### APPEAL SUMMARY

| <b>Appeal ID:</b> 16543                                     | <b>Project Address:</b> 1829 NW Lovejoy St                              |
| <b>Building/Business Name:</b> Royal Arms Condominiums      | <b>Fire Sprinklers:</b> Yes - Partial - Public spaces and corridors     |
| <b>Appeal Involves:</b> Alteration of an existing structure | <b>LUR or Permit Application No.:</b> 18-120415-CO                      |

# 1 UNIT DEMISING WALL

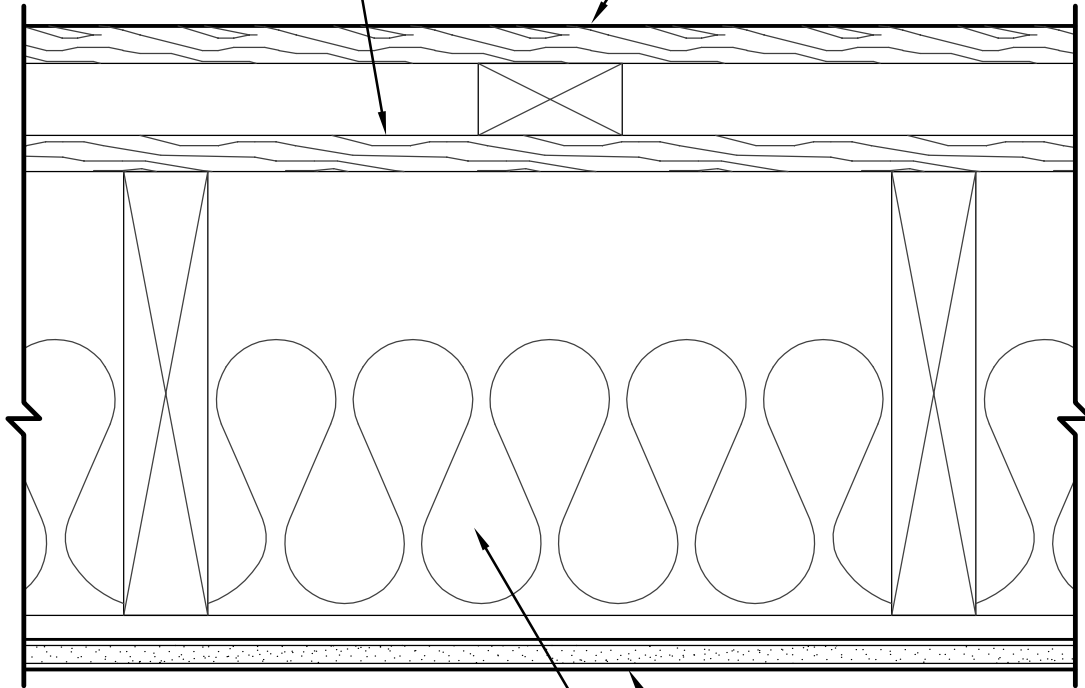
**Code Section** 420.2, 708.1 and 708.3

The proposed demising wall construction consists of the use of a proprietary gypsum sound board (Quiet Rock 530 RF Type X) over Type X or Type C gypsum board on existing 2x4 wood stud wall plates and staggered 1-3/4" x 2-3/4" wood studs at 12" on center with new 3 inch mineral wool insulation in stud cavity. Existing 7/8" plaster on wood lath comprises the other wall face of adjoining tenant.

**Reason for alternative** The existing demising walls are constructed with wood lath and plaster on wood studs. The lath and plaster has currently been removed on the remodeled dwelling unit side. Using Item W-4-W-79 from the 2018 International Existing Building Code Resource A Guidelines on Fire Ratings of

Archaic Materials and Assemblies, the plaster on wood lath can be construed as equivalent to 5/8" Type X gypsum board. Considering this information, it is feasible the existing lath and plaster with the proposed two new layers of gypsum board would provide an equivalent 1-hour rated wall assembly for separation walls of dwelling units.

## Appeal item 2

| <b>Proposed Design</b>        | <p>Refer to attached assembly and test report.</p> <p>The proposed demising wall construction consists of the use of a proprietary gypsum sound board (Quiet Rock 530 RF Type X) over Type X or Type C gypsum board on existing 2x4 wood stud wall plates and staggered 1-3/4" x 2-3/4" wood studs at 12" on center with new 3 inch mineral wool insulation in stud cavity. Existing 7/8" plaster on wood lath comprises the other wall face of adjoining tenant.</p>  |
| <b>Reason for alternative</b> | <p>The existing demising walls are constructed with wood lath and plaster on wood studs with no insulation in stud spaces. The lath and plaster has currently been removed on the remodeled dwelling unit side. The attached test report demonstrates Quiet Rock product achieved an STC 53 in accordance with NRCC TLA-04-051 using one layer of 5/8" Quiet Rock 530 RF and one layer of 5/8 inch Type C gypsum board secured to 2x4 wood studs at 24 inches on center with batt insulation in stud space. Although this tested performance of STC 53 is based on the use of gypsum board for the single layer, substituting the existing the lath and plaster for one layer of gypsum board with the existing staggered stud configuration in the proposed partition type would conservatively achieve an equivalent assembly that meets the air-borne sound code required minimum STC 50.</p> |

- 1. Alternate one hour wall assembly by comparison: Granted as proposed.**
- 2. Alternate STC sound wall assembly by comparison: Granted as proposed.**
- 3. Alternate one hour floor / ceiling assembly by comparison: Granted as proposed.**
- 4. Alternate STC / IIC floor / ceiling assembly by comparison: Granted as proposed.**
- 5. Determination of interior wall as non-bearing: Denied. Proposal does not provide equivalent Life Safety protection.**
